DART SERVICE INSTRUCTION

TO AMEND INSTALLATION INSTRUCTIONS IIN-D206-746 REV.A

DESIGN <i>B</i>	DRAWN BY <i>B</i>	DART AEROSPACE LTD HAWKESBURY, ONTARIO, CANADA	
CHECKED <i>PH</i>	APPROVED <i>#</i>	DRAWING NO. DSI 9341	REV. B SHEET 2 OF 2
DATE 07.01.02		TITLE BLOWER MOTOR ASSEMBLY	SCALE 1:4

D206-746-043 BLOWER MOTOR ASSEMBLY

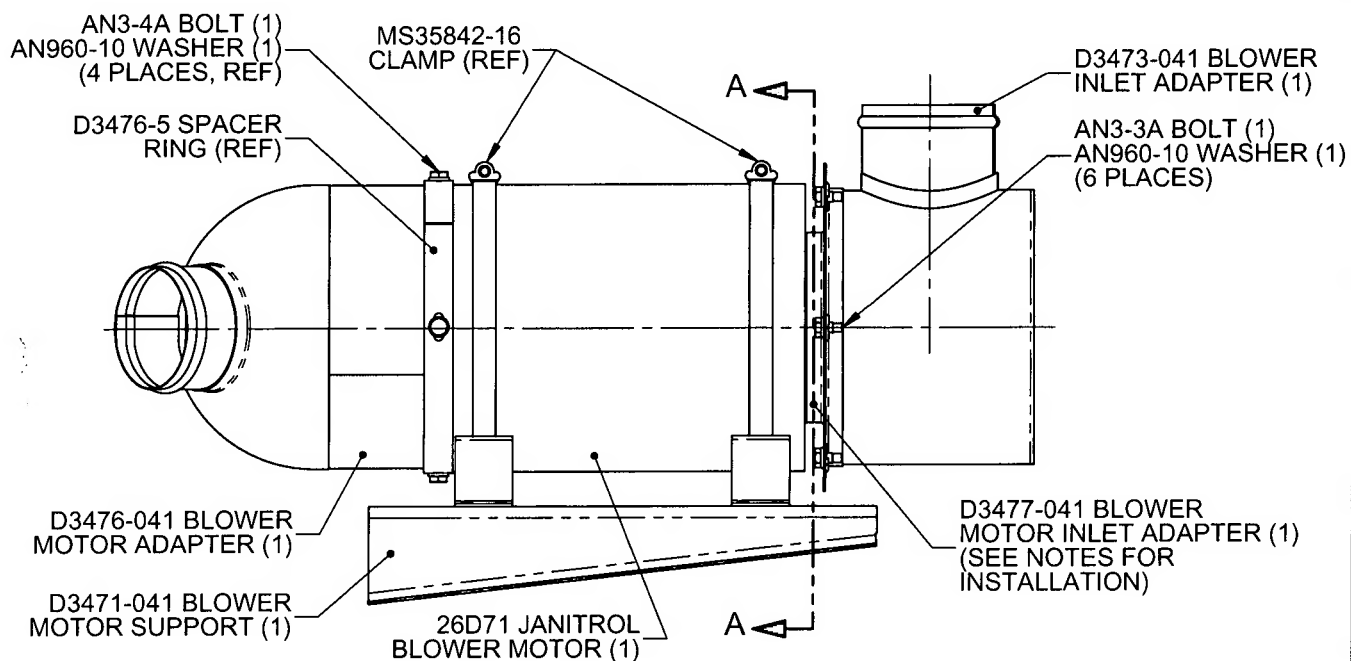
The Parts List of Installation Instructions IIN-D206-746 Rev. A should be amended as follows:

Furthermore, any mention of "Blower Motor Assembly" appearing in Installation Instructions IIN-D206-746 Rev. A, and Installation Drawing D206-746 Rev. A, should be replaced by D206-746-043 Blower Motor Assembly.

DETAIL B
SCALE 1:1

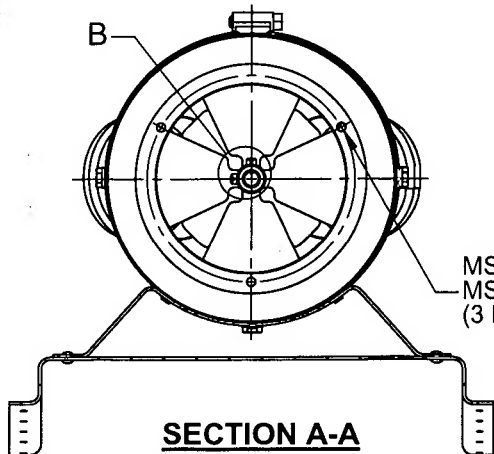
REPLACE EXISTING SET SCREWS
WITH D3585-1 SET SCREWS (2),
APPLY LOCTITE 226, TORQUE TO
50-70 in-lbs (5.6-7.9 N-m) AND SECURE
USING MS20995-025E LOCK WIRE
